MODEL	REV	CHANGE LIST	Model	CT3/5 MB BOARD	
			Page	FROM	TO
CT3/5 MB 31CT3MB0015 31CT3MB0031	1A	PAGE 2 --- Enable CLK48M from clocK generator for the PLL circuit of 7411, and disable the ocsillator circuit of PCI7411 PLL. PAGE 3 --- Remove H/W shutdown circuit that supported ADM1032. PAGE 4 --- Use X7R type to replace Y5V type for CPU Decoupling/Bypass capacitor. PAGE 10 --- Add a terminal resistor R706 for -CODE_RST# to improve signal quality. PAGE 11 --- 1. Add a 10K pull-up resistor on MCH_SYNC# for booting. 2. Change the power plane of PCIE_WAKE# from 3VSUS to 3V_S5 to solve system can't turn off issue. 3. Change the power plane of ICH_THRM# and SCI_# from 3VSUS to +3V to reduce leakage. PAGE 12 --- We can also use 5VSUS to instead of 5V_S5 to save cost of MOSFET(A06402). PAGE 15 --- Add a level-shift cicuit for EDID interface. PAGE 17 --- 1. Add a off-page and a EMI solution for CLK48M. 2. Remove the reserve resistors (R693~R695) of parallel interface for PCI1510. PAGE 18 --- Remove R696, connect controller and power switch directly . PAGE 19 --- Change R682&R683 value from 56 ohms to 0 ohm cause of BOM error at A-test. PAGE 22 --- 1. Change MC3 type from Y5V to X7R to improve

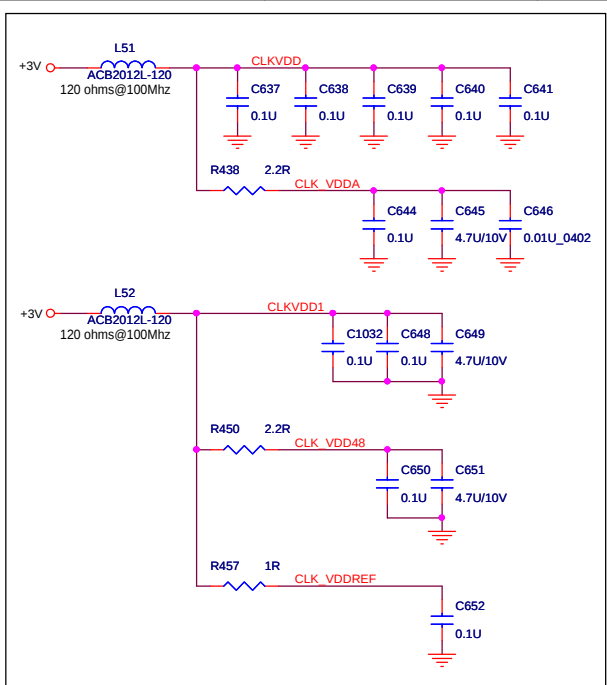
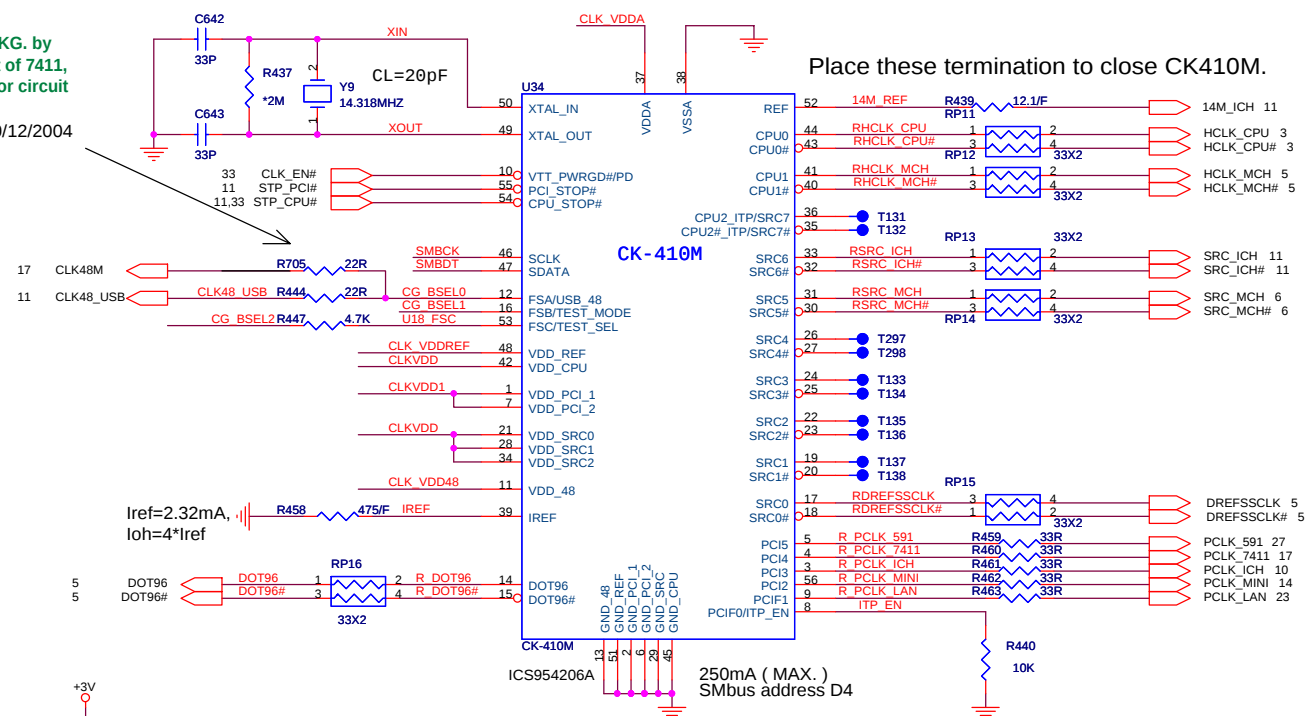
SI stage:
Enable CLK48M from CKG. by
R705 for the PLL circuit of 7411,
and disable the oscillator circuit
at PCI7411 side.

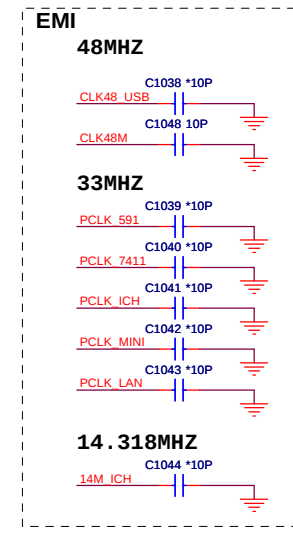
PV stage:
Add C1048 for CLK48M to get better EMI
performance.
Sting 11/29/2004

H/W MONITOR

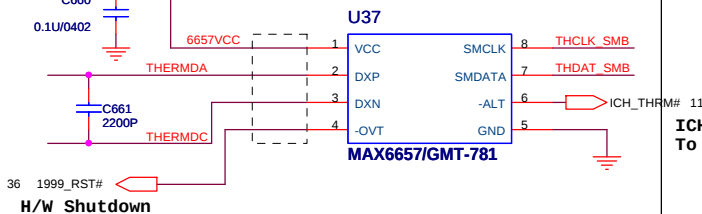
SI stage:
Remove H/W shutdown circuit
(R613&Q54)that supported
ADM1032.

CPU de-coupling capacitor

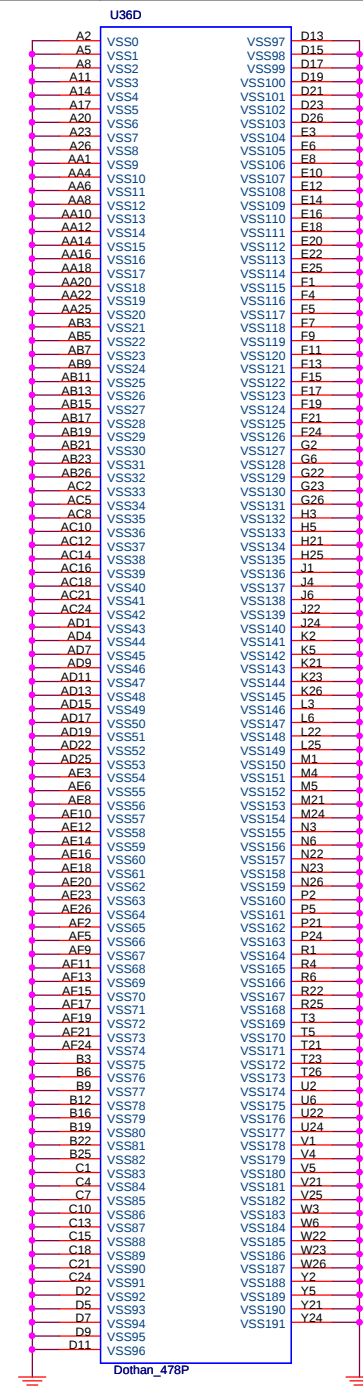
SI stage:
Use X7R type to replace Y5V type for Decoupling/Bypass capacitor.

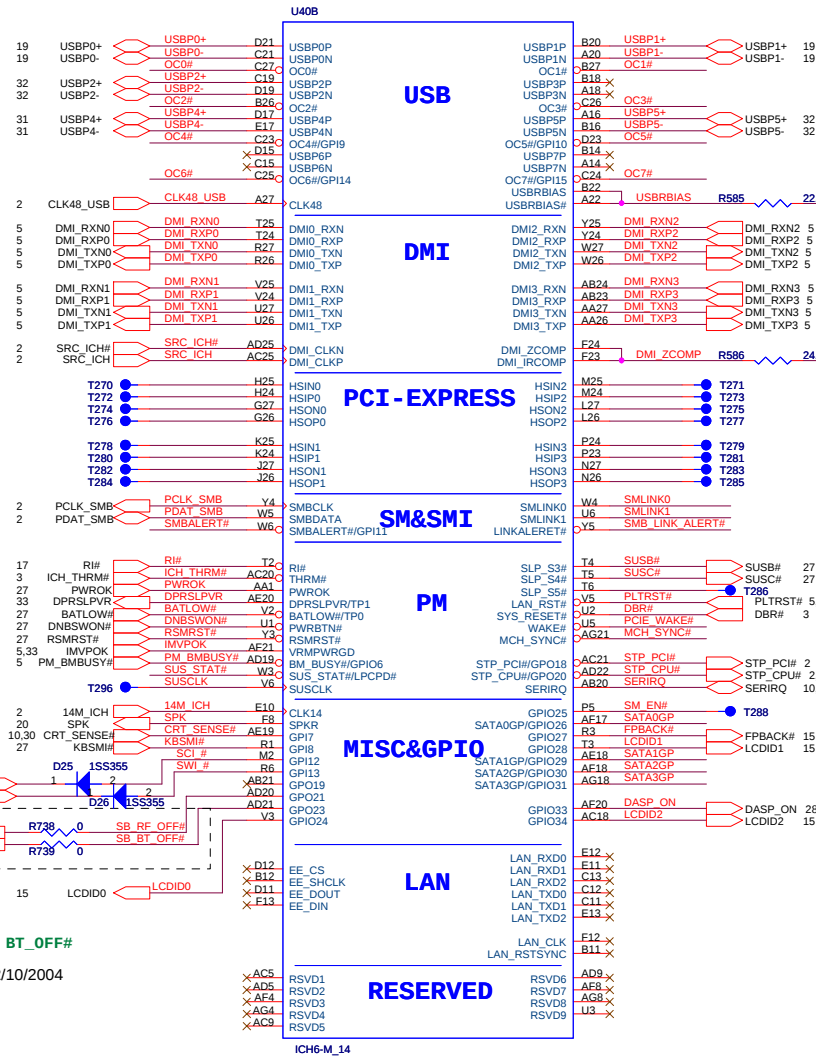
SI stage: Intel suggested us to add a terminal resistor R706 for -CODEC_RST to improve signal quality.

PV stage:
1. Add RF_OFF# and BT_OFF# circuit.

1. Change the power plane of PCIE_WAKE# from 3VSUS to 3V_S5 to solve system can't turn off issue.
2. Change the power plane of ICH_THRM# and SCI_# from 3VSUS to +3V to solve leakage issue.

SI stage:
R589 should be populated, because MCH_SYNC# is internally ANDed with PWROK. System will not booting without this pulled-up resistor.

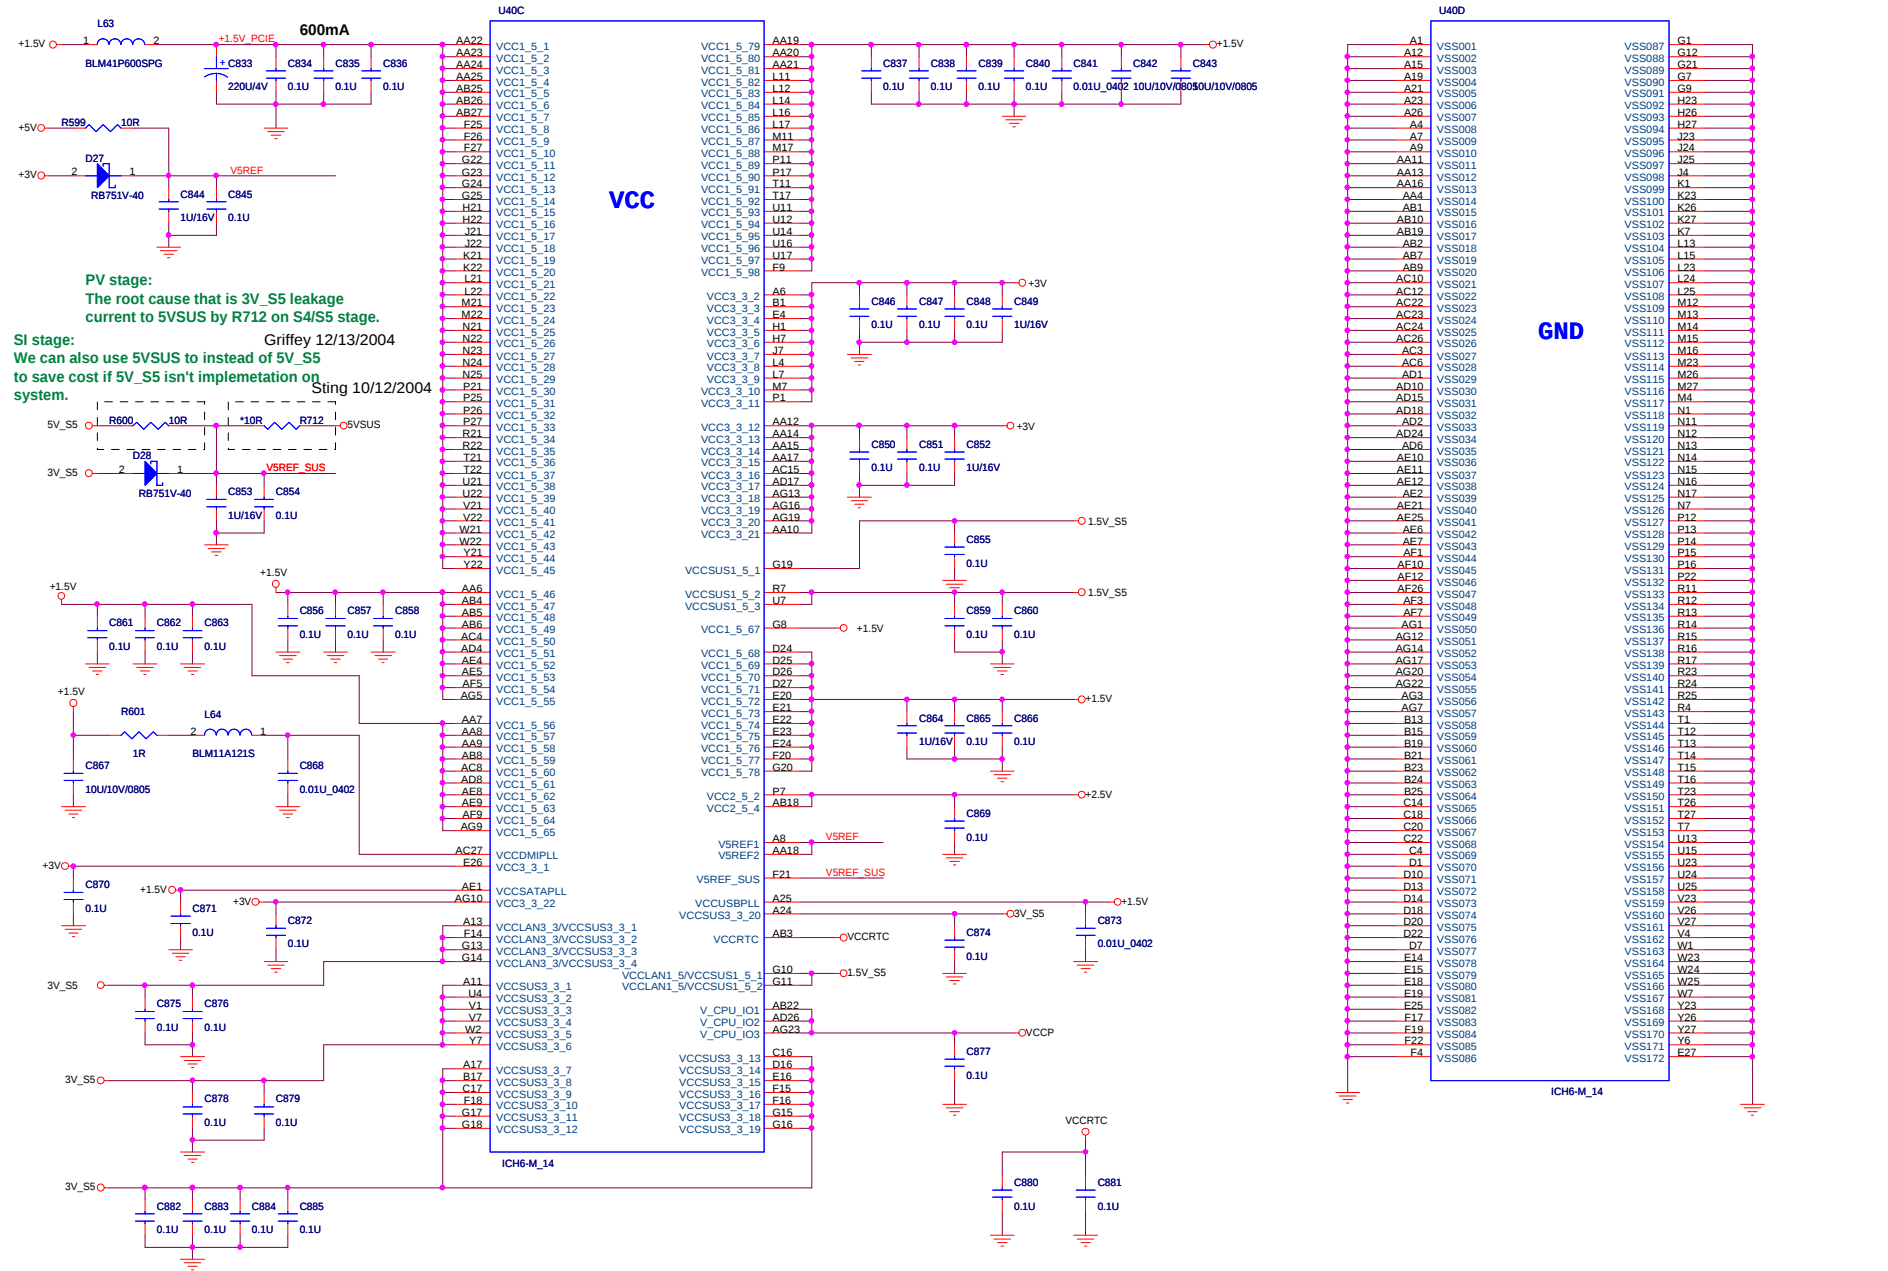
PV stage:
The root cause that is 3V_S5 leakage current to 5VSUS by R712 on S4/S5 stage.

SI stage:
We can also use 5VSUS to instead of 5V_S5 to save cost if 5V_S5 isn't implementation on system.

CARDBUS POWER SWITCH

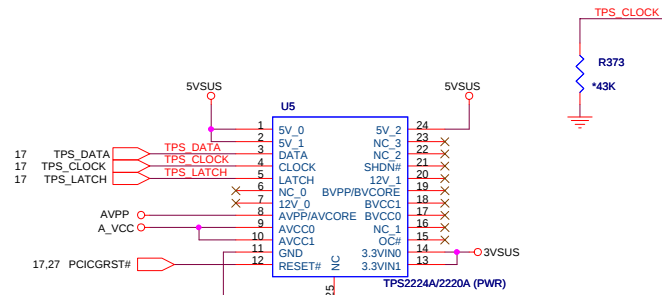
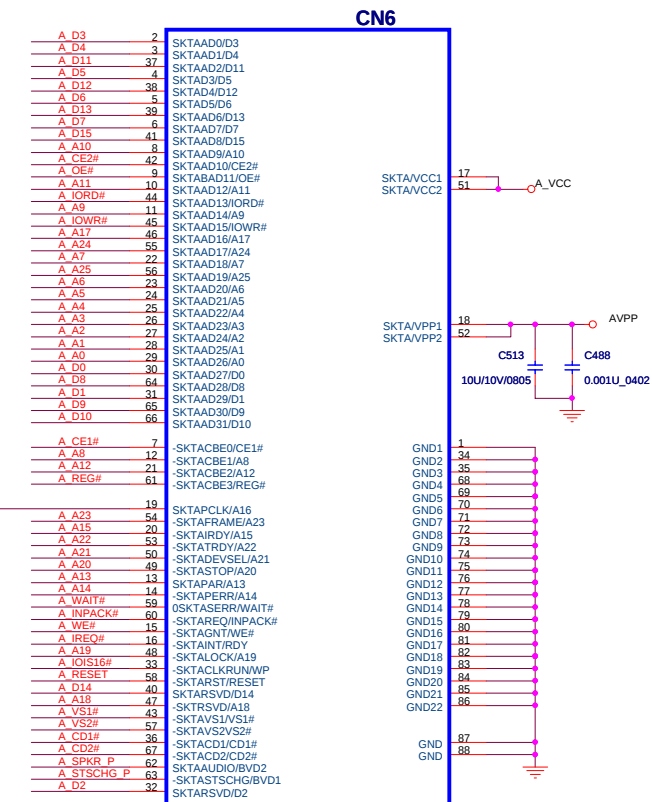
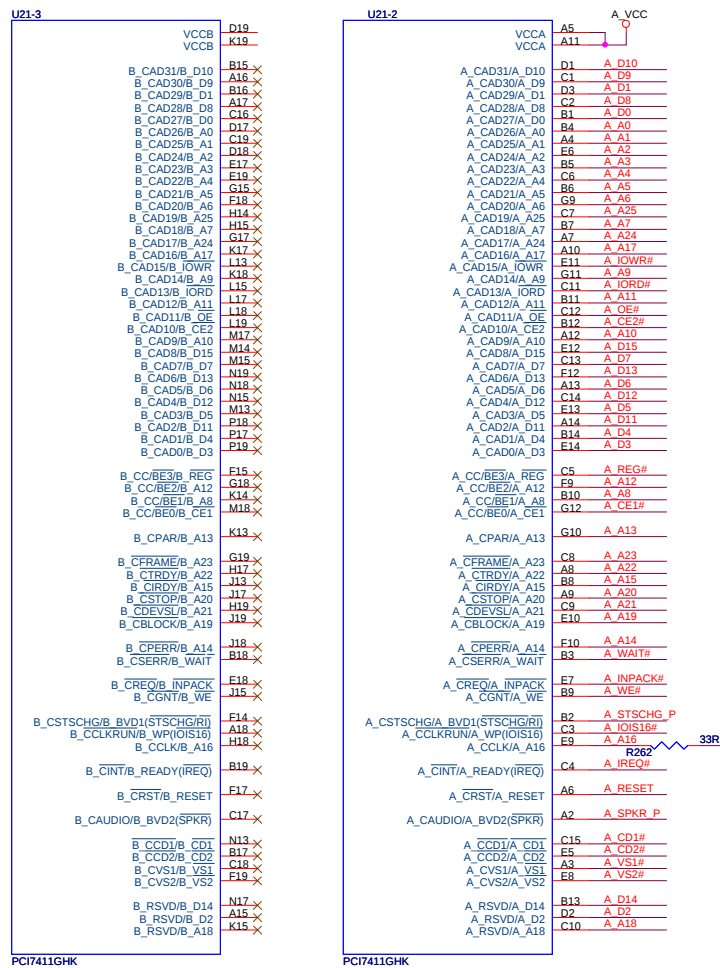
PV stage:
Remove unused PCI1510RVGF circuit.

CARD POWER CONTROL

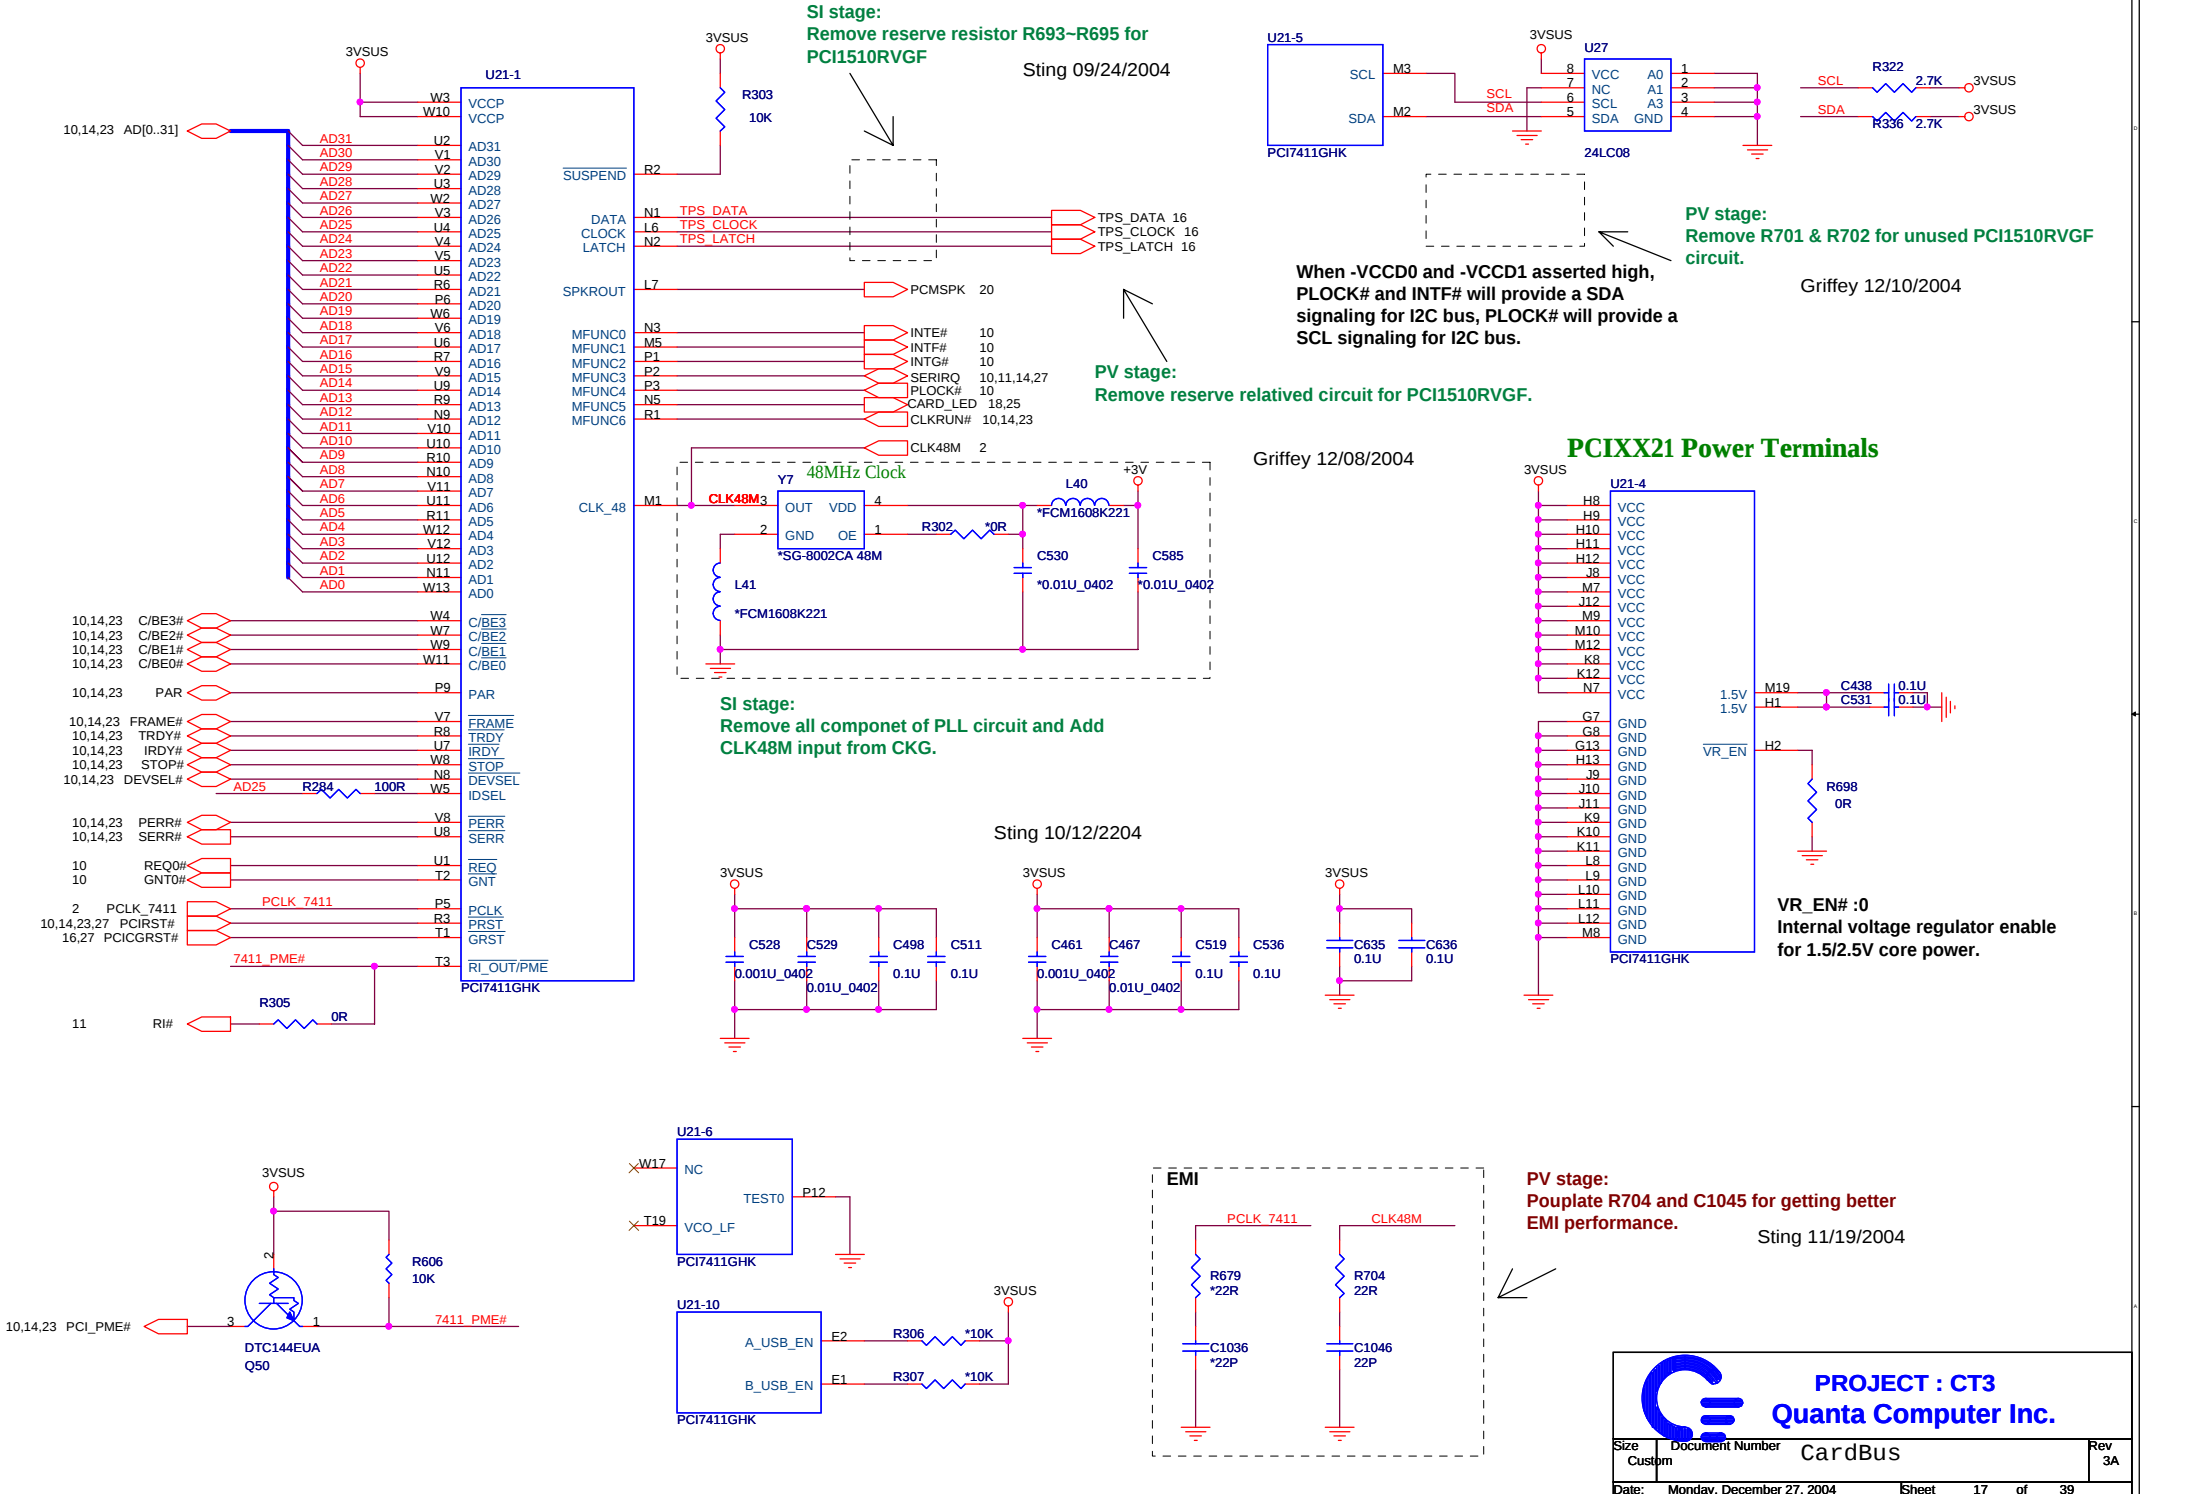
PV stage:
Remove reserve related circuit for
PC1510RVGF.
Griffey 12/08/2004

SI stage:
Remove reserve resistor R696 fro
PC1510RVGF.
Sting 10/12/2004

IEEE 1394 CONNECTOR

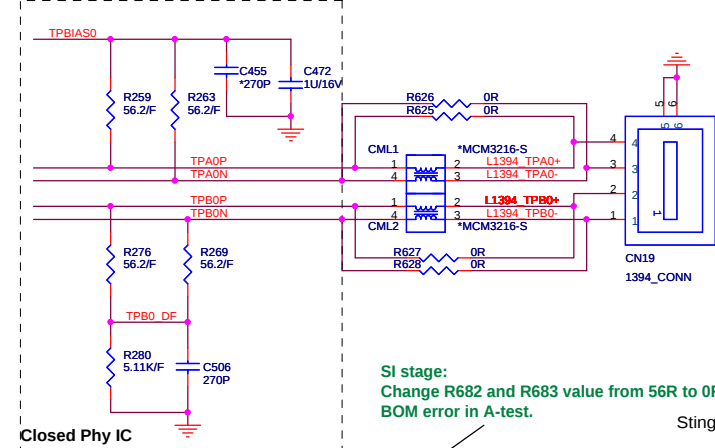
SI stage:
Change R682 and R683 value from 56R to 0R cause of
BOM error in A-test.
